**U800**  
 Neptune 225 pin 0.8mm pitch  
 69K64  
 NEPTUNE 2.5.3

GSM SERVICE SUPPORT GROUP	2003.08.07
Level 3 Schematics	Rev. 1.0
A760	8404678R01_R0
Michael Hansen, Alexander Bühler	Page 1 of 1

**A760 8404678R01\_Rev0**

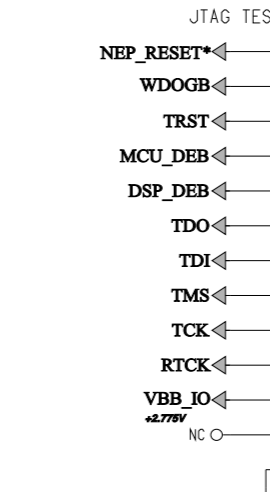
RX\_EN Needs to be reassigned.  
 Not a Layer1 pin.

VDDA to be connected  
 when Ref. Osc. Finalized.

bypass caps should be close  
 to the pins they are bypassing
